# UNITED STATES PATENT AND TRADEMARK OFFICE

## Office Action Summary

10/044,368

## DETAILED ACTION

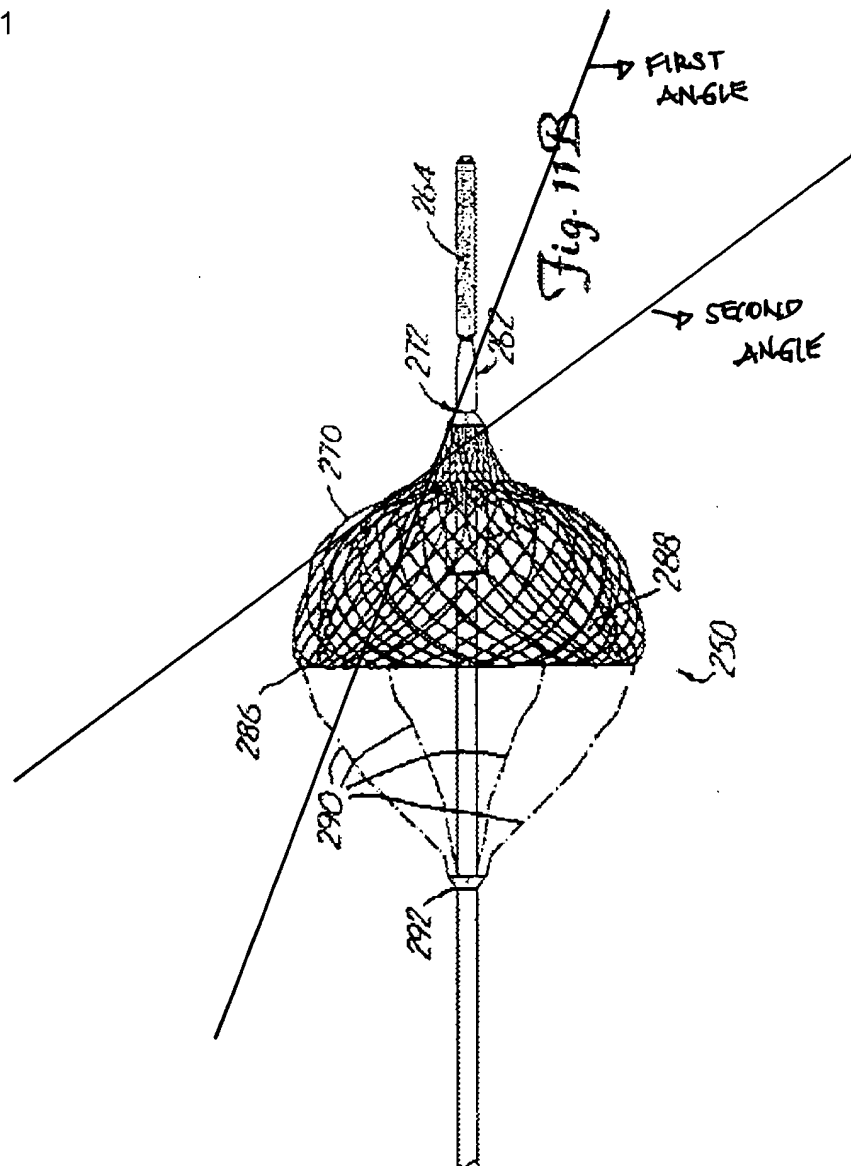
As to claims 52, 72 and 92, Fig. 11B discloses a filter assembly comprising an elongate shaft **265**, a filter **270** disposed and attached to a distal end of the shaft, the filter including a filtering region and an attachment region (col. 19, line 66 – col. 20, line 8). The filtering region includes a major opening defined adjacent the proximal end (seen in Fig. 18B) and is comprised of a single layer of filter membrane that is folded

onto itself to define a filter basked and extending between the major opening and the distal end of the filtering region, the filtering region comprising apertures to allow the passage of blood through the filtering region; the filter membrane further comprising a first tapered portion defining a first angle that is lesser (different) than a second angle defined by a second tapered portion (see attached Fig. 11B).
